Intel® 82571EB/82572EI Ethernet Controller

Specification Update

*December 2008
Revision 6.0*

25. Auto-Cross Sample Timer (PHY-related Issue).

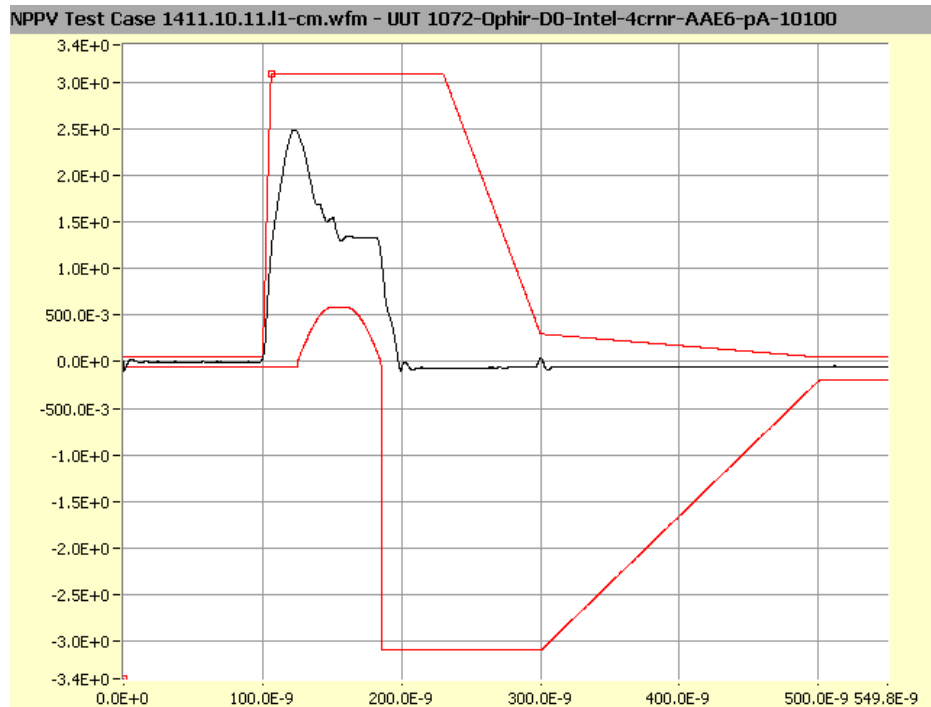
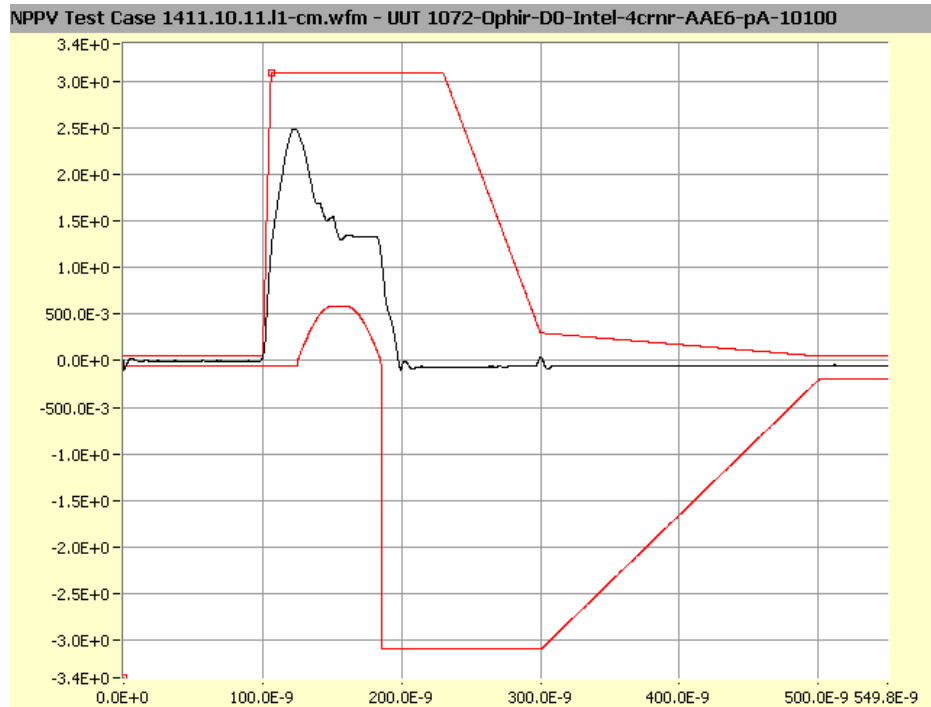
- Problem:** The Auto-Crossover State Machine (Auto-MDIX) has two states: MDI_MODE and MDI-X_MODE. The time that should be spent in each mode is defined as an integer multiple of a pseudo-random number and a sample timer, which is defined to be 62 ± 2 ms. The PHY is sometimes waiting for a non-integer multiplication of the 62 ± 2 ms – as defined by the specification.
- Implication:** None
- Workaround:** None
- Status:** No Fix: There are no plans to fix this erratum.

3. System-Level EMI Test Can Be Affected by 490MHz Harmonic Seen In 10Base-T Waveform Spectrum.

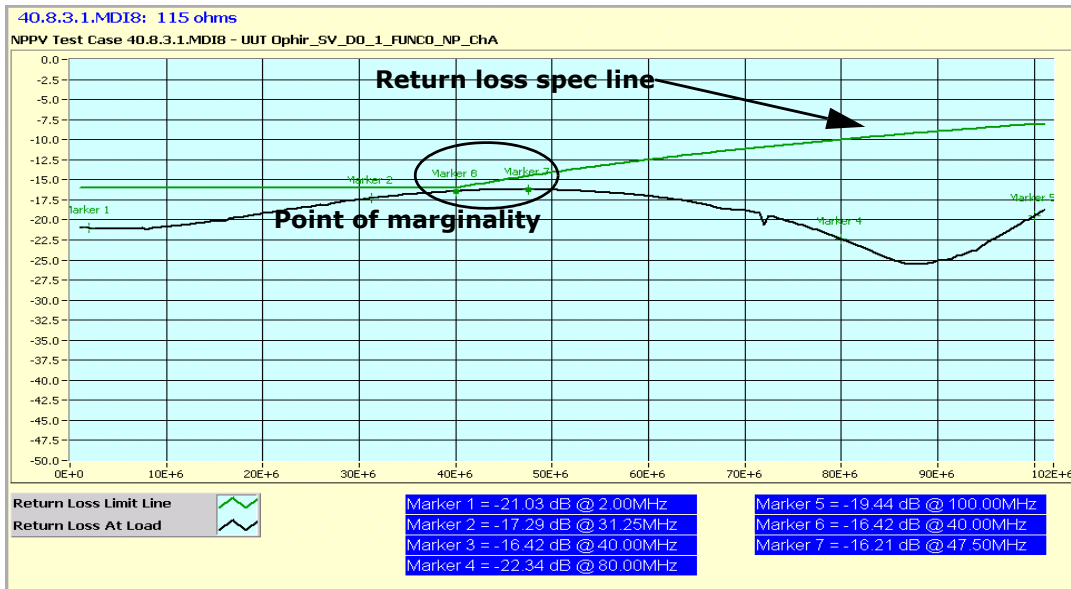
Clarification: This is not a violation of any IEEE specification. This harmonic may, however, contribute to EMI (electro-magnetic interference) in a system-level check at this frequency.

There is no impact on system-level performance.
